EI 03-019 Page 2 of 2

TRANSMITTED MATERIALS: Attached to this EI are revisions to Section 644 Sign Structures, Section 645 Signs, Section 715-01 Structural Steel, and Section 730-27 Permanent Variable Message Signs.

Make the following changes to the Standard Specifications dated January 2, 2002.

SECTION 644 - OVERHEAD SIGN STRUCTURES

FIGURE 644-1

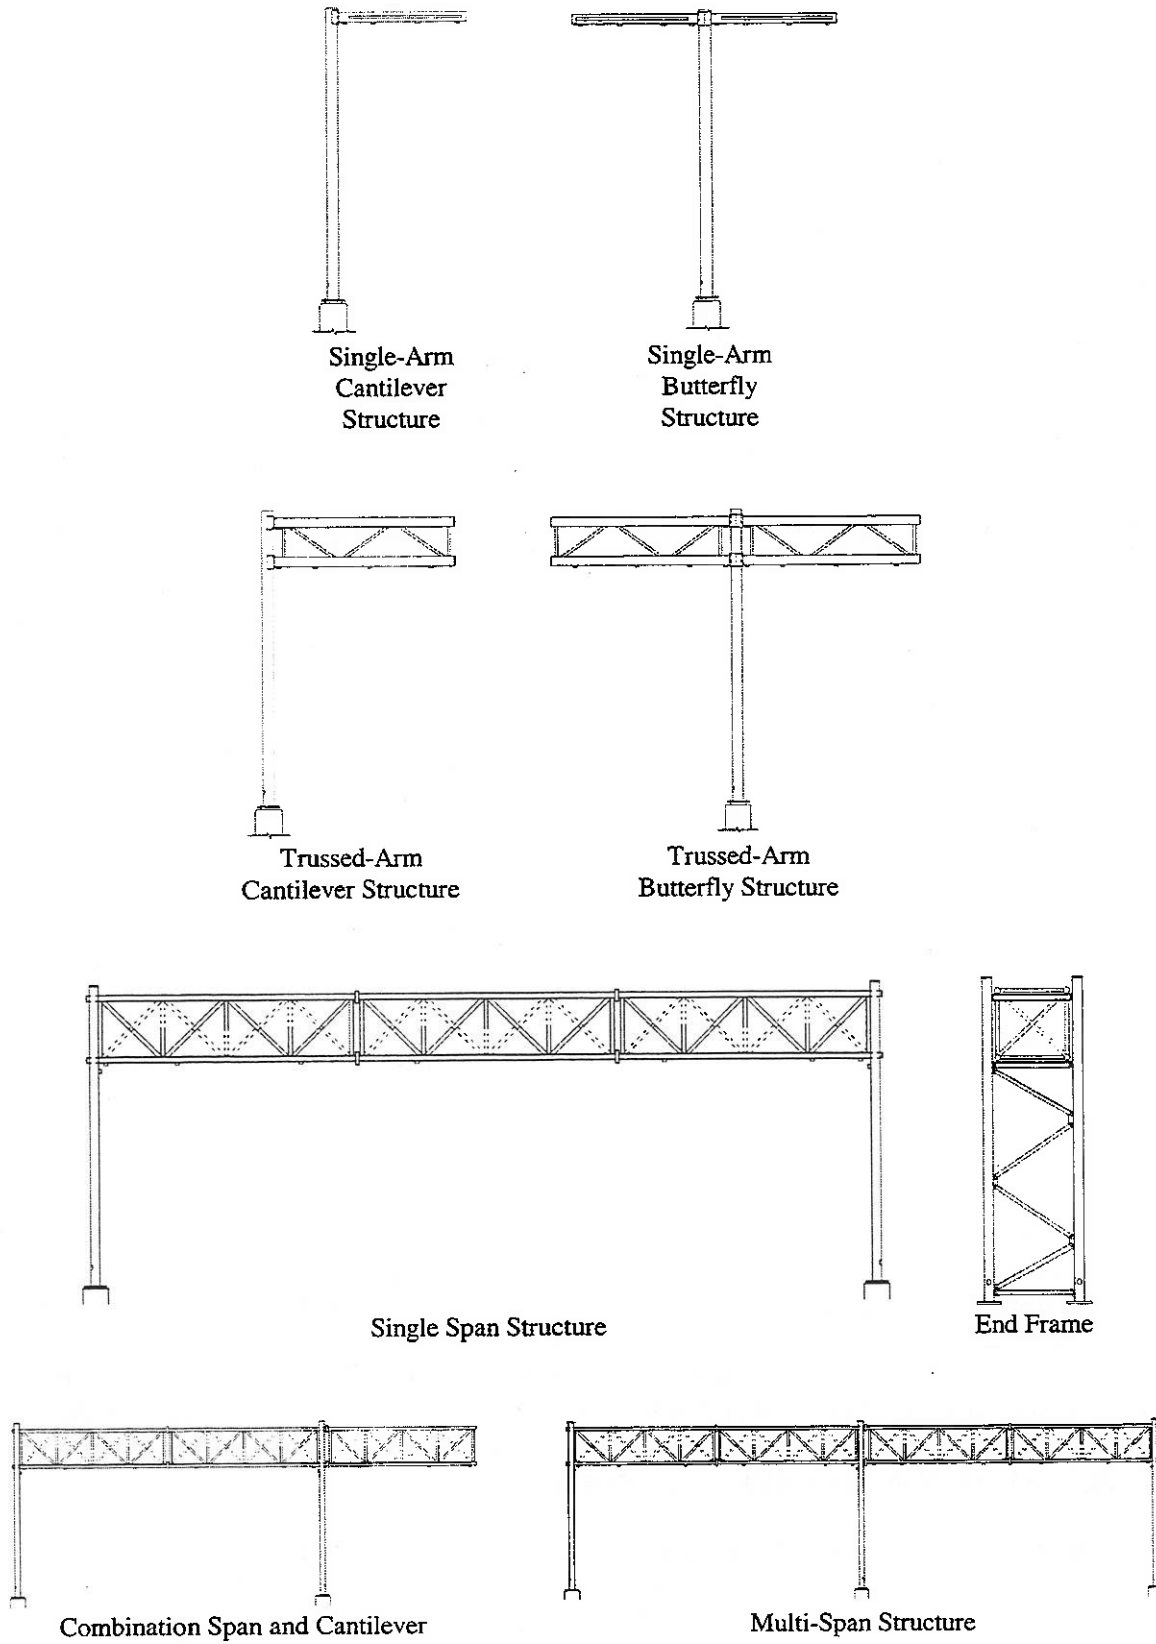
OSS are classified into the following three standard types (See Figure 644-1).

A. Single Arm Cantilever. Single (horizontal) arm supported by a single (vertical) post.

B. Trussed Arm Cantilever. Two trussed arms supported by a single post. (If the arms are not trussed, the structure shall be classified as Non-Standard).

C. Span. Single span, four-chord (quad-chord) superstructure supported by trussed end posts.

FIGURE 644-2

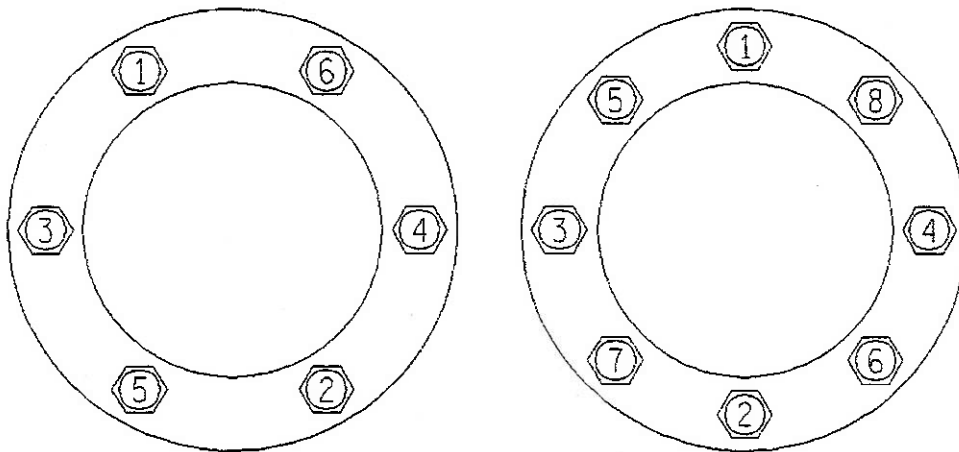
6. Fully tighten all top nuts according to the torques listed in Table 644-1. The tightening sequence shall be as shown in Figure 644-2. There shall be no rotation of the leveling nut during this procedure. 30
